May 6, 2013

Re: Proposed Hydro-electric Generating Station at the Bala Falls

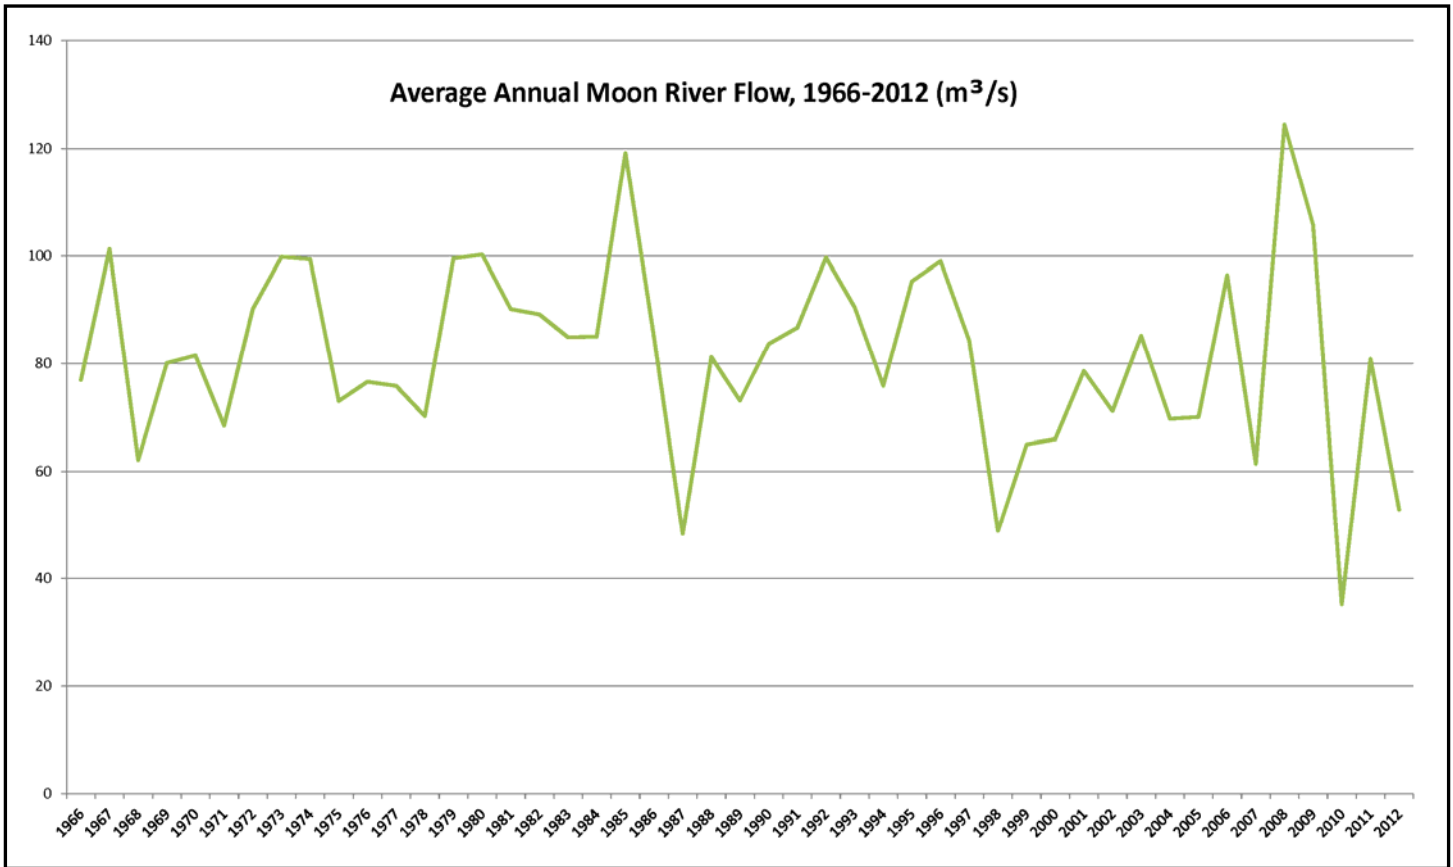
- 3) Further, due to climate change, weather patterns are now more volatile. For example, the graph below of data from the Water Survey of Canada shows that indeed the average annual flow through Bala is becoming more volatile.

This spring's flooding of the Muskoka watershed is certainly an example of the increasingly volatile weather patterns.

Therefore, responsible planning requires that the proposed cofferdam be in place for less than the 15-week low-flow period of the summer.

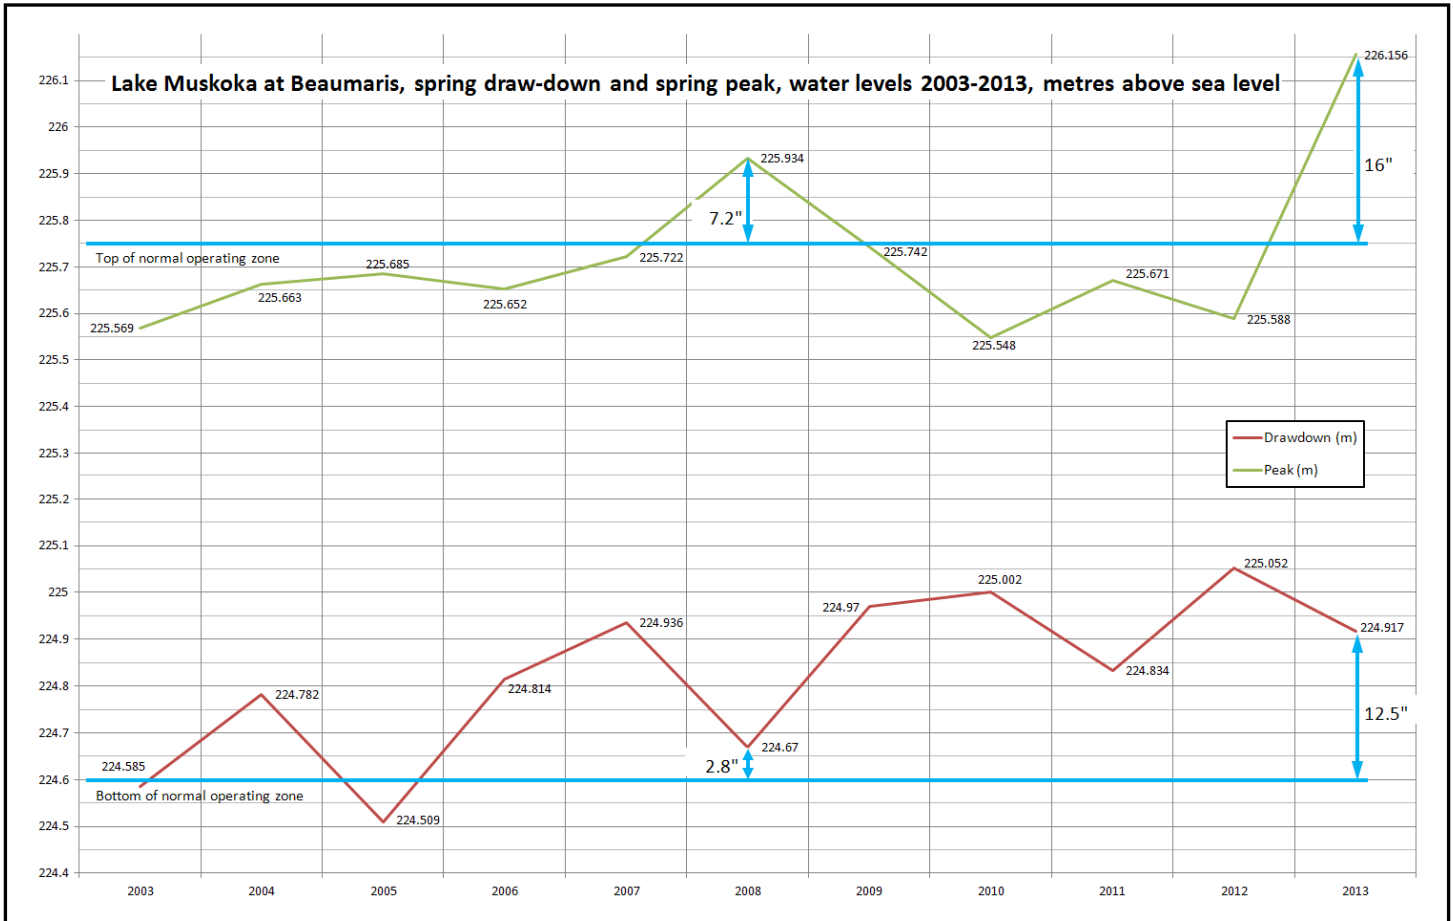
- 4) The Muskoka River Water Management Plan (MRWMP) defines several benchmark levels, one of which is the *Normal Operating Zone*, which for Lake Muskoka ranges from 224.6 metres above sea level (MASL) up to 225.75 MASL. These limits are shown by the cyan horizontal lines in the graph below.

The graph below shows that MNR staff do draw-down the water level of Lake Muskoka to different levels each year, however, we note the following:

- a) In anticipation of a larger-than-usual spring freshet, in 2008 there was additional draw-down. Unfortunately, even this additional draw-down was not adequate, and the water level of Lake Muskoka peaked 7.2" above the Normal Operating Zone, causing flooding that year.

b) While the water level this 2013 spring was drawn-down more than it was in 2012, this draw-down was entirely inadequate, and not even as much as in 2008. In fact, in 2013 the draw-down could have and should have been 12.5" more. Ultimately, the flooding of Lake Muskoka was 16" over the normal operating zone and was the worst in memory.

This demonstrates that the magnitude of high-flow events cannot be predicted. Therefore to ensure public safety, as is required by the Lakes and Rivers Improvement Act, obstruction of the north channel must not be permitted when past history has shown that high-flow events occur.
